**TRANSMITTAL OF UNITED STATES ENVIRONMENTAL PROTECTION AGENCY (U.S. EPA) AND
OHIO ENVIRONMENTAL PROTECTION AGENCY (OEPA) COMMENT RESPONSES FOR ADDITIONAL
MONITORING WELLS**

ADDITIONAL INFORMATION REQUESTED BY U.S. EPA 3612
ON THE U.S. DEPARTMENT OF ENERGY'S
OU5 CONDITIONALLY APPROVED WORK PLAN ADDENDUM
FOR ADDITIONAL MONITORING WELLS

RESPONSES TO OHIO EPA COMMENTS ON THE U.S. DEPARTMENT OF
ENERGY'S OUS CONDITIONALLY APPROVED WORK PLAN ADDENDUM
FOR ADDITIONAL MONITORING WELLS

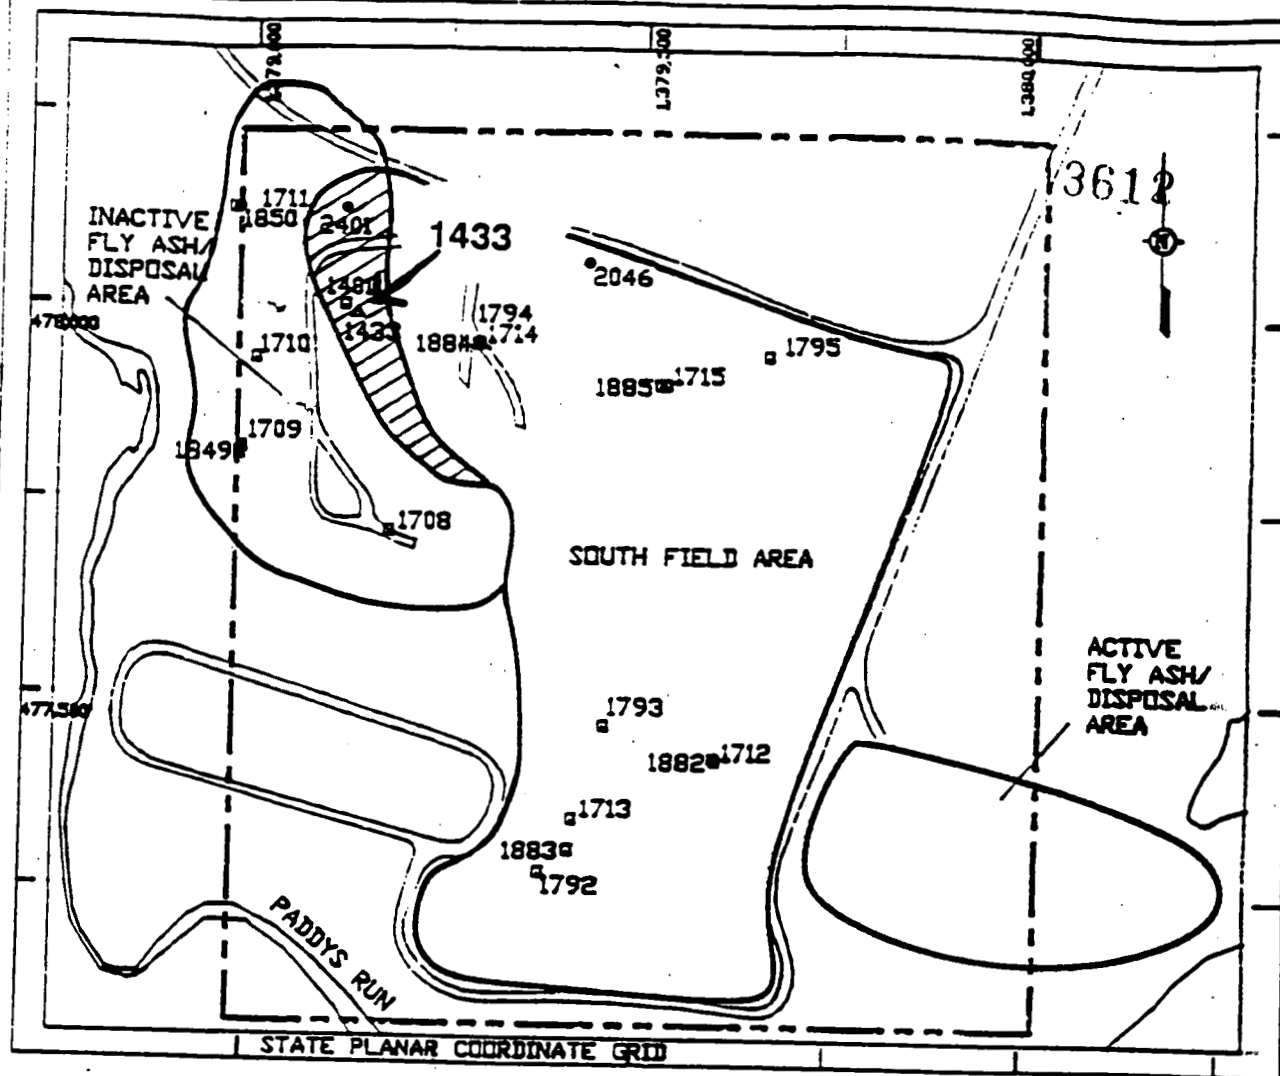
Comment: The U.S. DOE must provide further information regarding the location and depth of the monitoring well located within the inactive fly ash pile.

Response: The well coordinates of monitoring well 1711, referenced in the original response, are 4781216.51N, 1378968.82E (state planar coordinate system). The location of this well is shown in Figure 1. This well was completed at a depth of 15.5 feet and screened at an interval of 13 to 15 feet in the perched water-bearing zone. Since installation, the water yields in the well have been insufficient to permit development and sampling. Due to the conditions present at Well 1711, no samples or perched water/leachate from within or below the contaminated fill in the inactive fly ash area have been collected and analyzed.

This information is still considered necessary and a new location is being proposed for the installation of a 1000-series well (well 1433) in the inactive fly ash area. The proposed location of well 1433 is also shown in Figure 1. A work plan addendum for Operable Unit 2 is currently being prepared for this scope of work. This information will be used to support both the OU2 and OU5 Remedial Investigation/Feasibility Study.
